NRC Resolution of facility comments.

SSES LOC– 26 NRC EXAMINATION SSES POST–EXAMINATION COMMENTS

From the exam analysis and post–exam review with the applicants SSES has identified three written exam questions (SRO 77, SRO 78, and SRO 80) where a change in the answer key is requested. During the exam there were no questions asked by the applicants regarding these three questions. The requested changes to the questions are founded in procedure requirements and the bases are described in detail below. The complete examination analysis is included as part of the submittal package.

Generator Capability Curve and GO-100-012, Power Maneuvers

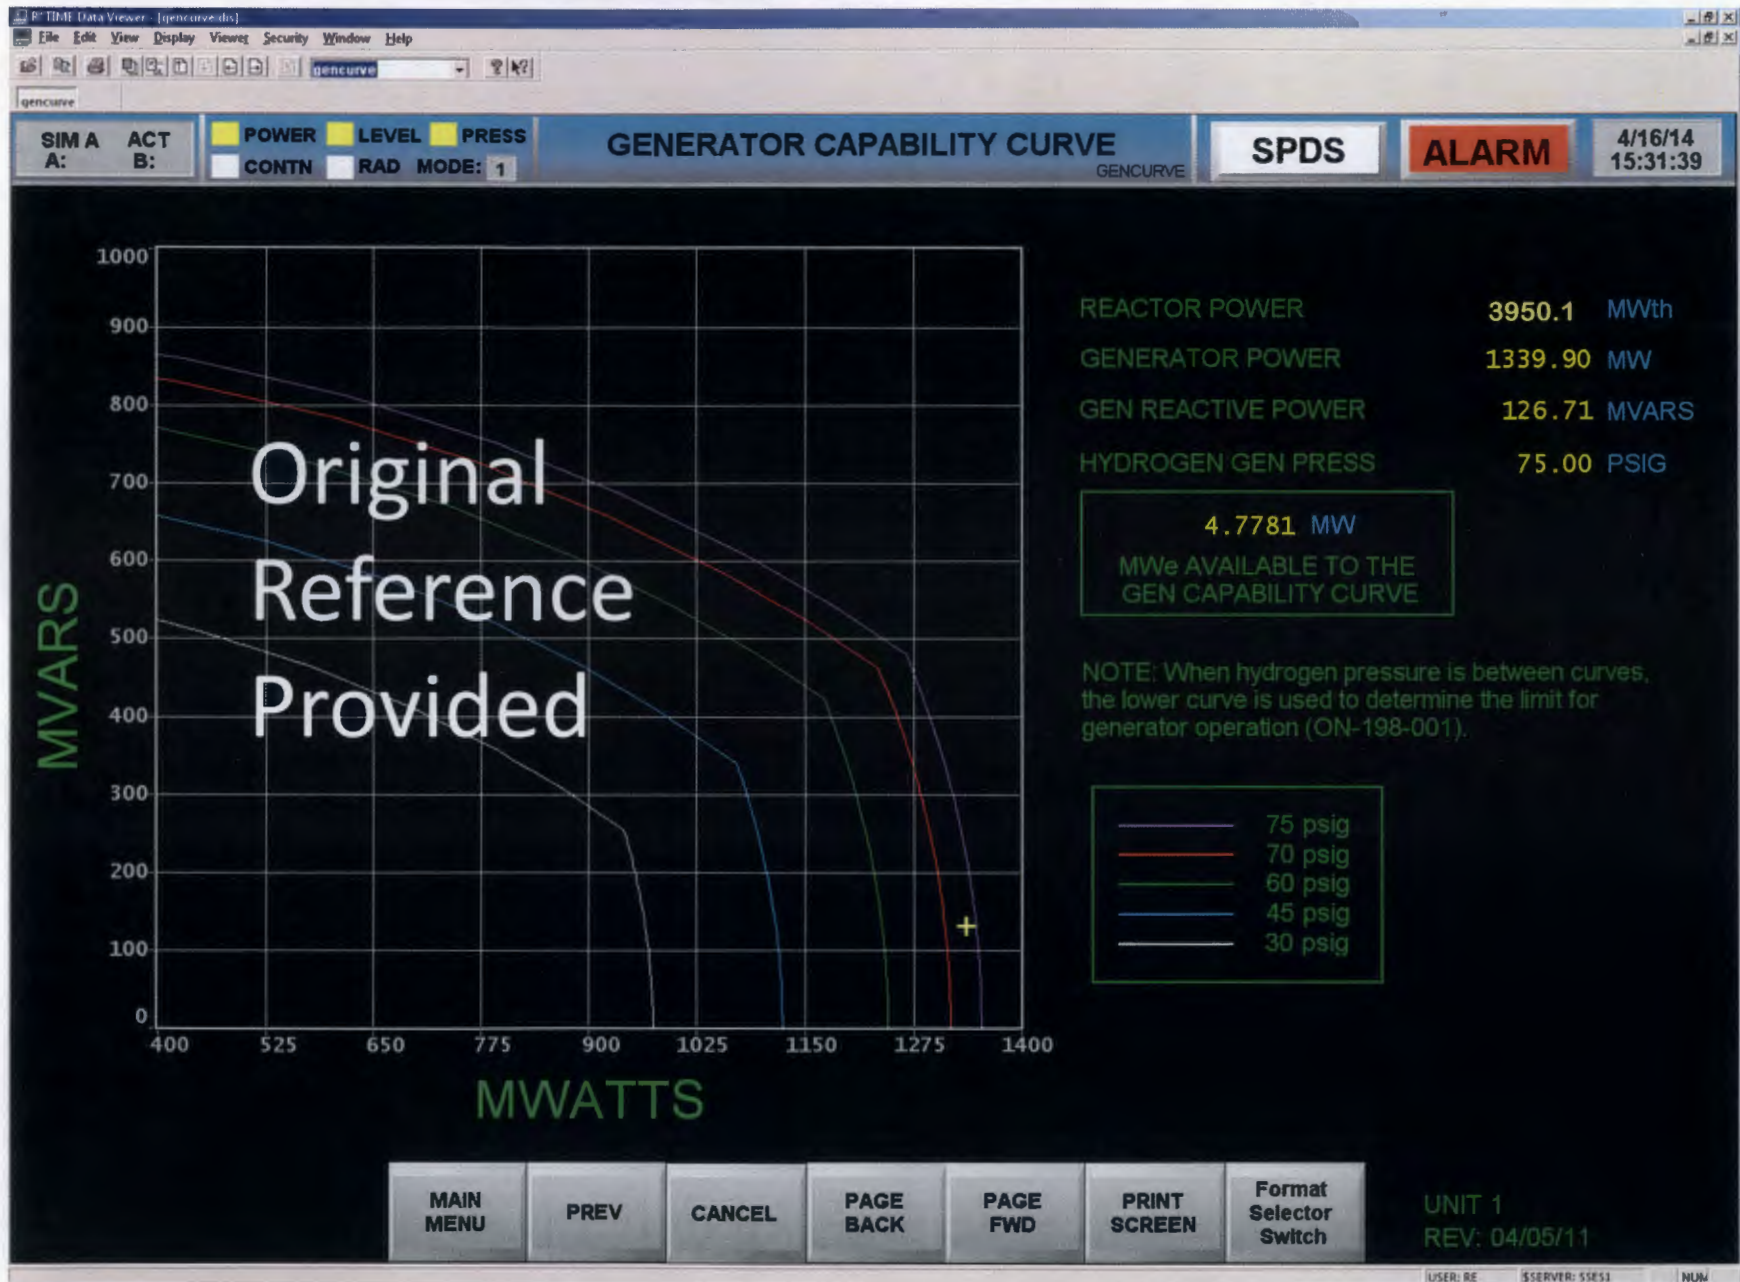
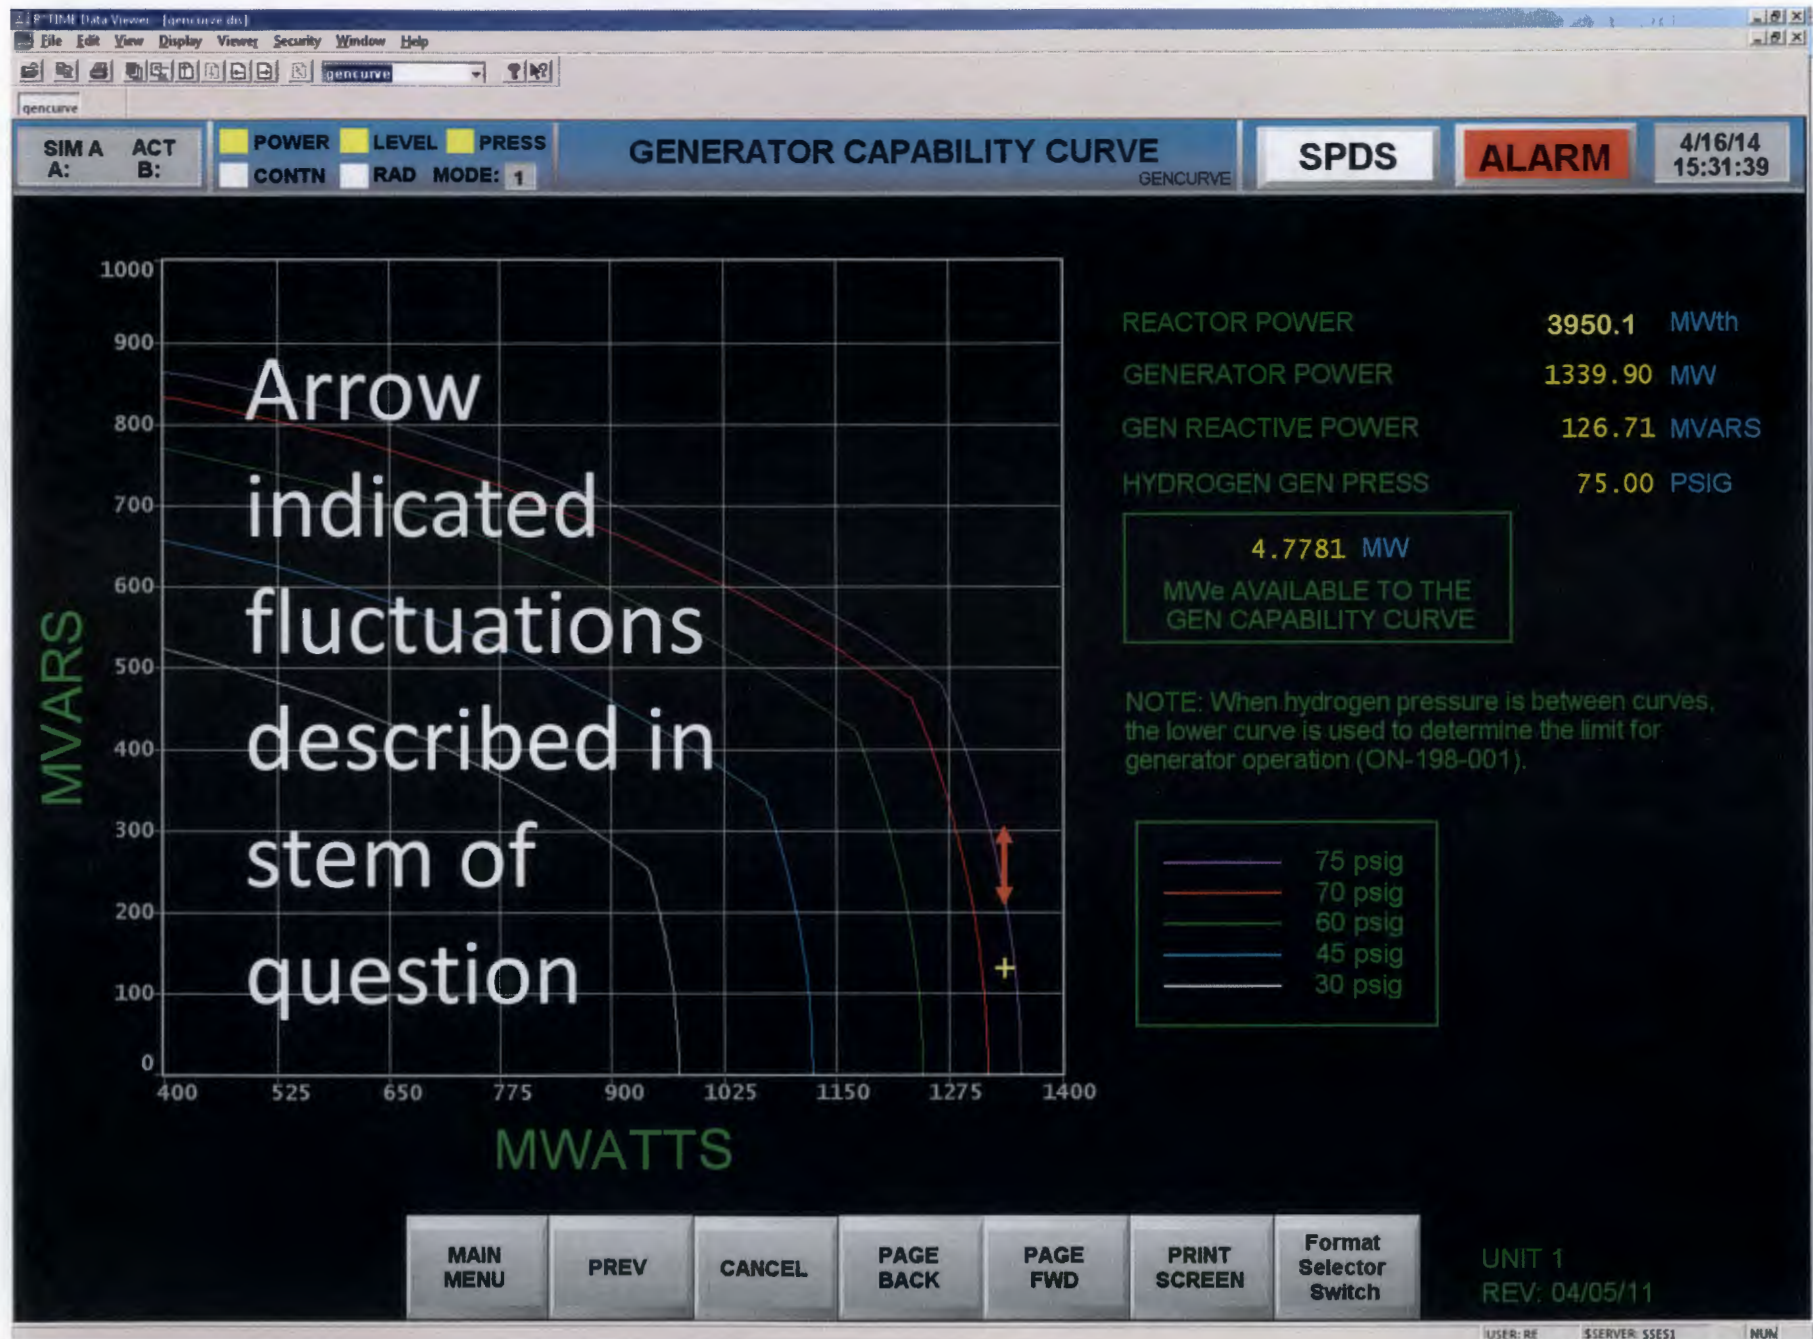
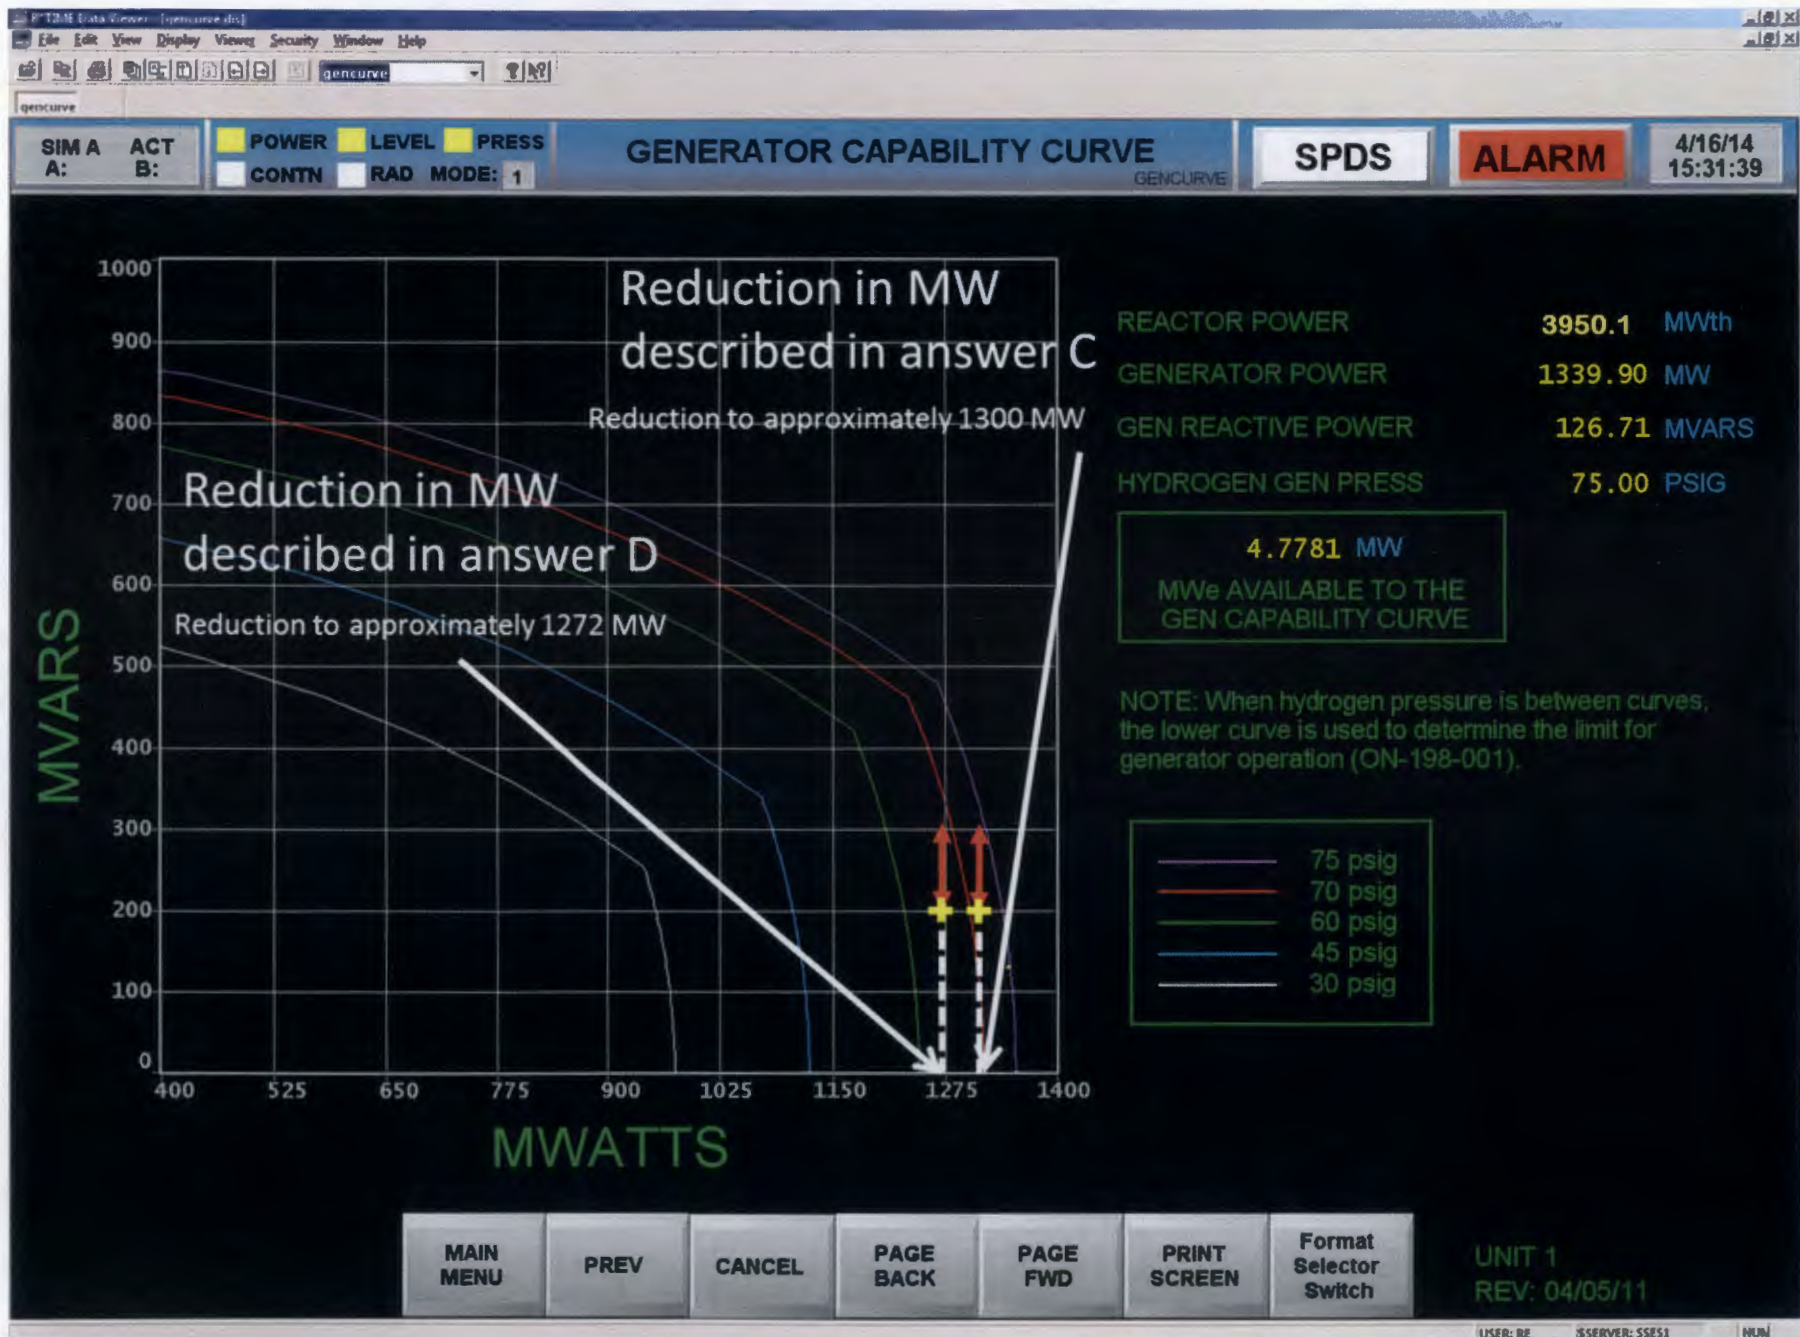
Q77: Facility Comment: Accept a second correct answer as a subset of the original correct answer.

Justification For Change – refer to reference diagrams below

ON-198-001, Unit 1 Main Generator MVAR Control for AUTO Voltage Regulator Operation when Synched to the Grid, requires the operator to maintain the Main Generator parameters within those established by the Generator Capability Curve. Section 3.5 is directed to be performed if MVAR output is approaching or exceeding the curve limits. The information provided in the stem of the question establishes conditions outside the curve limits. Oscillations between 200 to 300 MVAR places the generator operation above the 75 psig curve limit as indicated on the plant computer reference given to the applicants.

Correctly applying the procedure requirements of ON-198-001 step 3.5.3 and GO-100-001, step 5.3.11.b, results in reducing reactor power which reduces generator power to restore operation within the limits of the curve. These procedural steps however do not indicate the amount of adjustment necessary. On-198-001 does direct restoring operation to the allowable region as described in step 3.5 NOTE (2) d.

Selecting response C, Reduce core power per the CRC instructions to lower generator load to restore positive margin to the capability curve and Perform GO-100-012, Power Operations for an unplanned power reduction as the correct answer results in a reduction of generator MW to restore “positive margin.” The magnitude of positive margin is not described by the procedure requirements. Interpolation of the numbers on the curve given results in a reduction to approximately 1300 MW to reenter the allowable region.

Selecting response D, Immediately reduce core power per the CRC instructions to lower power by 5 percent Perform GO-100-012, Power Operations for an unplanned power reduction as the correct answer results in a reduction of generator MW to restore “positive margin” also. Lowering core power by 5 percent gives a corresponding decrease of generator power by 5 percent resulting in a final output power of 1272 MW. The magnitude of positive margin is not described by the procedure requirements. Interpolation of the numbers on the curve provided to the applicants results in a reduction to approximately 1272 MW providing acceptable margin which would be reasonable for the conditions given. Directing a power reduction of 5 percent would be an acceptable operating practice as the SRO would be expected to establish a target power level when ordering a reactivity change. Note: SSES does not agree with the original question explanation of choice D which stated that ON-198-001 allows up to 2 minutes to restore margin, so immediate action is not required. ON-198-001, Note (2), step 3.5.3 states, “Allow the Automatic Voltage Regulator no greater than two (2) minutes to reduce MVAR output if MVAR output exceeds Generator Capability Curve.” Therefore, immediate action to reduce reactor core power is required and would be expected.

Response D is a subset of response C as a 5 percent reduction provides an operating point within the allowable range. An evaluation of the bases for selecting either C or D as an acceptable response reveals that in both cases the generator is operating within the established limits of the capability curve and all procedure requirements are followed.

Given an evaluation of the above criteria SSES recommends accepting both responses C and D as correct answers.

NRC Resolution: The facility submittal provides a clear walkthrough on graphs as to why their proposed second correct answer is a subset of the original answer.

Accept two correct answers as proposed.
